Access Compliance Report

Public Rights-of-Way

(Curb Ramps)

Intersection ID: 53893	Main Street: PERTH_MOOR_RD	Cross Street: HAMILTON_BRIDGE_RD	Location: SE
ADA ID: CC38819AE319	Ramp Type: Perp	Initial Pass/Fail: Fail	Overall Compliance: No
Severity Score: 8.75			
Codes/Mitigation Info/Possible Solution		Field Measurements/Component Compliance

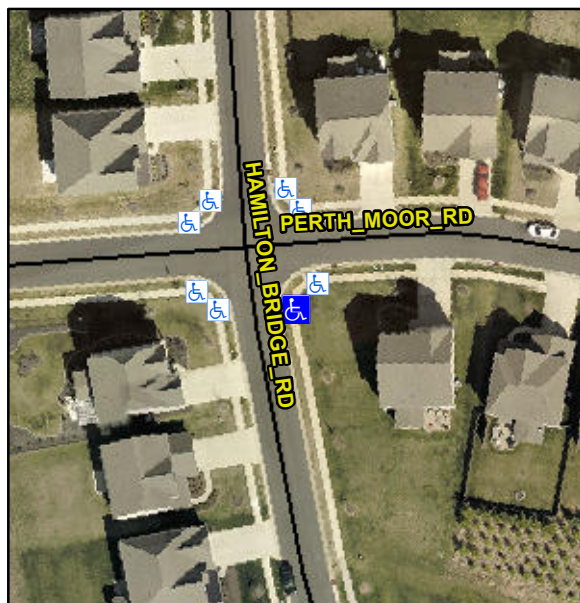
Not Found, R304.5.1

Compliance	Description	Data	Compliance	Description	Data
N/A	Ramp Length (in)	46.0	Yes	Ramp Slope (%)	5.5
No	Ramp Width (in)	45.0	Yes	Ramp XSlope (%)	0.4
N/A	Flare Type LT	N/A	N/A	Flare Type RT	N/A
N/A	Flare Slope LT (%)	N/A	N/A	Flare Slope RT (%)	N/A
N/A	Flare Traversable LT?	N/A	N/A	Flare Traversable RT?	N/A
N/A	Landing Length (in)	N/A	N/A	DWS Provided?	N/A
N/A	Landing Width (in)	N/A	N/A	DWS Contrast?	N/A
N/A	Landing Slope (%)	N/A	N/A	DWS Length (in)	N/A
N/A	Landing X Slope (%)	N/A	N/A	DWS Full Width?	N/A
N/A	Landing Curb? (Y/N)	N/A	N/A	DWS Offset (in)	N/A
N/A	Shared Landing?	N/A			
N/A	Gutter Ponding?	N/A	N/A	Gutter Slope (%)	N/A
N/A	Gutter Lip Ht (in)	1.5	N/A	Gutter X Slope (%)	N/A
N/A	Painted X Walk1?	No	N/A	Painted X Walk2?	N/A
	X Walk 1 Direction	To W		X Walk 2 Direction	N/A
N/A	X Walk 1 Width (in)	N/A	N/A	X Walk 2 Width (in)	N/A
	X Walk 1 Slope (%)	2.3		X Walk 2 Slope (%)	N/A
	X Walk 1 X Slope (%)	1.6		X Walk 2 X Slope (%)	N/A

Remove & Replace Entire Ramp.
